UNITED STATES PATENT AND TRADEMARK OFFICE

10/775,223

Office Action Summary

DETAILED ACTION

Fig. 4

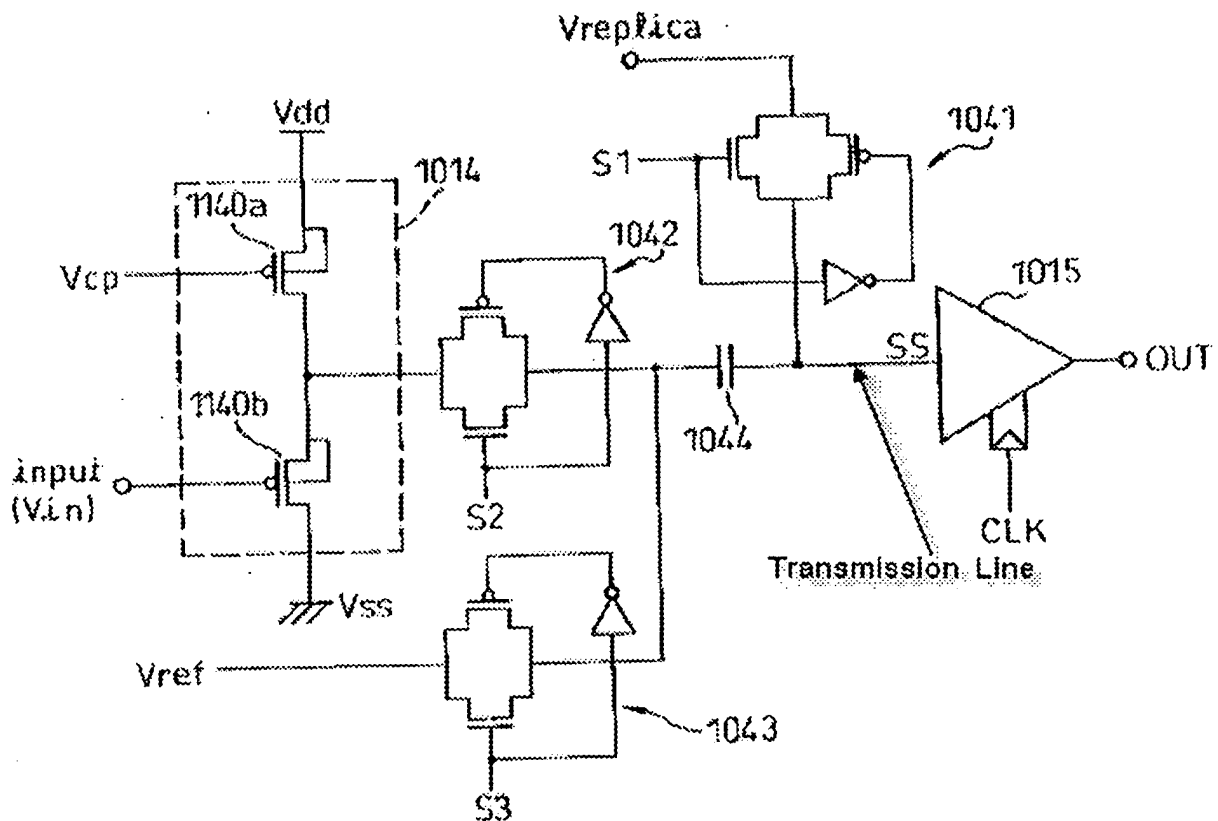
With respect to claim 1, Tamura teaches a signal transmission apparatus (fig. 4), comprising:

a signal transmission line (e.g., transmission line) (see fig. 4 below) having a transmitting end (1014) (fig. 4), a receiving end (1015) (fig. 4), and a characteristic impedance (see, for example, paragraph [0009]), including a signal-line element having a resistance-capacitance delay (e.g., the transmission apparatus has a resistance-capacitance delay as shown with various resistive and capacitive components in the figure) (see fig. 4), for transmitting a digital signal input (V_{in}) (fig. 4) at the transmitting end (see fig. 4);

a first driver (1014) (fig. 4) having an inverter structure (e.g., 1014 has an inverter structure) (see fig. 4) and an on-resistance, for supplying the digital signal to the transmitting end of the signal transmission line (see fig. 4);

a power-ground transmission line pair for supplying power to the first driver (e.g., power-ground Vdd and Vss supplying power to the driver 1014) (see fig. 4), having a characteristic impedance low enough to drive a sum of the on-resistance of the first driver and the characteristic impedance of the signal transmission line (see fig. 4);

a first receiver (e.g., decision circuit 1015) (fig. 4) having a differential amplifier structure (see, for example, decision circuit 1005 of fig. 3 showing a detailed version having a differential amplifier structure) (fig. 3, fig. 4), for receiving the digital signal from the receiving end of the signal transmission line and detecting the received digital signal (see fig. 4); and

a first directional coupler (1044) (fig. 4) connected between the first driver and the transmitting end of the signal transmission line (see fig. 4) for blocking a direct-current component of the digital signal and passing a wideband alternating-current component of the digital signal (i.e., the capacitor 1044 blocks dc component and passes ac component) (see fig. 4).

With respect to claim 2, Tamura teaches wherein all signal-line elements from output interconnections in the first driver to input interconnections in the first receiver, including all signal-line elements in the signal transmission line and all signal-line elements in the first directional coupler, are metallic (i.e., the transmission line and the capacitor plates are inherently made of metal in order for current to conduct) (see fig. 4).

With respect to claim 7, Tamura teaches wherein the first directional coupler is connected between the receiving end of the signal transmission line and the first receiver (i.e., the capacitor 1044 is connected between the receiving end and the receiver 1015) (see fig. 4), and no directional coupler is connected between the first driver and the transmitting end of the signal transmission line (i.e., no capacitor is present at the transmitting end) (see fig. 4).
